April 11, 2017

SUBJECT: CLOSURE MEMORANDUM SUPPORTING THE LIMITED
REVISION OF NUREG-0800 BRANCH TECHNICAL POSITION
5-3, "FRACTURE TOUGHNESS REQUIREMENTS"

Enclosure 2 documents the NRC staff's technical assessment of MRP-401 (BWRVIP-287), "Assessment of the Use of NUREG-0800 Branch Technical Position 5-3 Estimation Methods for Initial Fracture Toughness Properties of Reactor Pressure Vessel Steels" (ADAMS Accession No. ML15265A040), which supports the industry's opinion that there is no need to consider BTP 5-3 non-conservatism in P-T limits and PTS evaluations for pressurized water reactors (PWRs) for 60 years of operation. This enclosure focuses on the reassessment of non-conservatism in BTP 5-3 Positions B1.1(3) and B1.1(4) regarding the RT_{NDT} estimation and B1.2 regarding the USE estimation. For Position B1.1(3), the NRC staff verified the MRP's statistical analyses and concludes that considering additional margin is acceptable to ensure conservative behavior when using RT_{NDT} from this position in P-T limits and PTS evaluations. For Positions B1.1(4), since the MRP report's information is not sufficient to support a statistical analysis, the NRC staff performed a modifie

Figure 1 Data analysis results from Figure 10-4 of TLR-RES/DE/CIB-2014-011

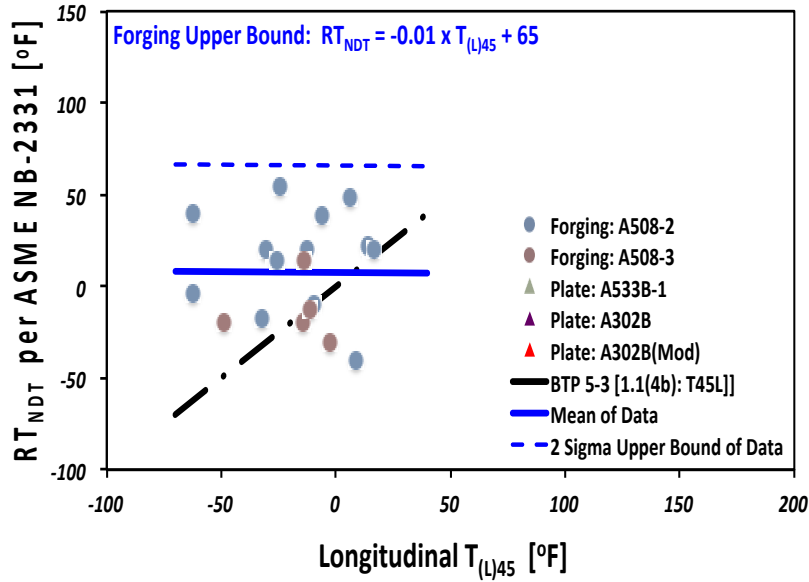
A plot of the data analysis based on the NRC TLR and the plot of the current analysis summarized in Table 1 are presented below for comparison. Figure 1 is a reproduction of Figure 10-4 from the NRC TLR. Figure 2 is a plot of the same data following Position B1.1(4) faithfully. Figure 2 indicates that many data points that were predicted by the NRC TLR approach in Figure 1 to be non-conservative (i.e., above the BTP 5-3 line) are now conservative based on the current approach. This supports the NRC staff's conclusion that the NRC TLR approach of using the Charpy curve over a range of test temperatures, instead of using the Charpy data at a single test temperature as required by Position B1.1(4), is overly conservative.

For plates, Figure 10-4 of the NRC TLR shows that the Position B1.1(4) line is bounding except for two data, which nevertheless are very close to the bounding line. Considering the above finding that the NRC TLR approach regarding Position B1.1(4) is overly conservative, the NRC staff has no doubt that Position B1.1(4) would bound all plate data if the same approach that was employed to produce Figure 2 results for forgings is employed for plates.

Figure 2 Current data analysis results from Table 1

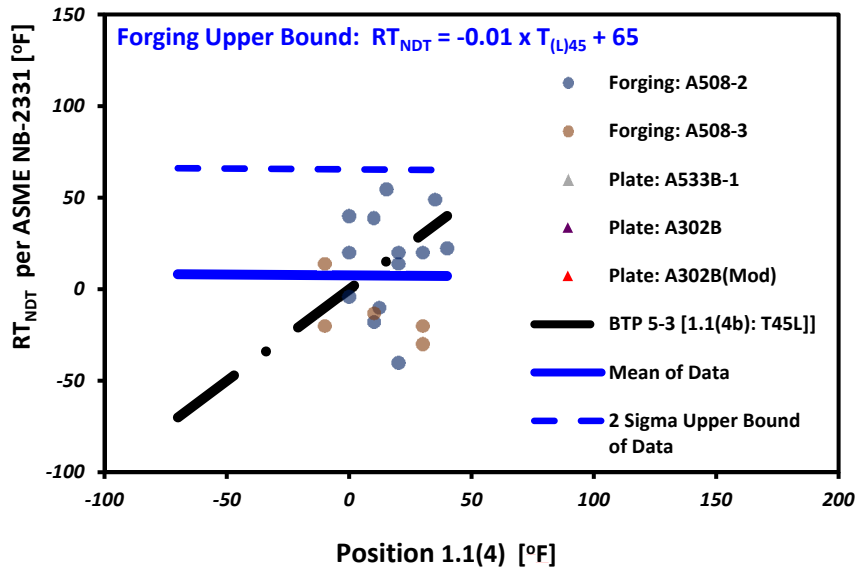
Based on the Table 1 results from the data analysis by NRC using the REAP database for forgings, the NRC staff determined that continued use of Position B1.1(4) to determine the mean initial RT_{NDT} values for plates and forgings is adequate. However, since Table 1 indicates that using a 2σ value of approximately 33.4 °C (60 °F) will bound all error (in the last column of Table 1) associated with using Position B1.1(4) for forgings, and since Figure 10-4 indicates that if Position B1.1(4) is followed faithfully, all plate data will be bounded, the staff concludes that for any applications using this position, an acceptable approach is to use a σ_1 of 0 °F for plates and a σ_1 of 30 °F for forgings. These σ_1 values are combined with σ_Δ in accordance with RG 1.99, Revision 2 to calculate the margin in estimating the ART for irradiated materials.

Use of this σ_1 value in the margin calculation for P-T limits and PTS evaluations will not be implemented in the proposed BTP 5-3 for 72 EFPYs because the risk-informed approaches in Enclosures 5 and 6 indicated that the resulting changes in risk considering this σ_1 value do not meet the NRC criterion for implementing a new requirement.
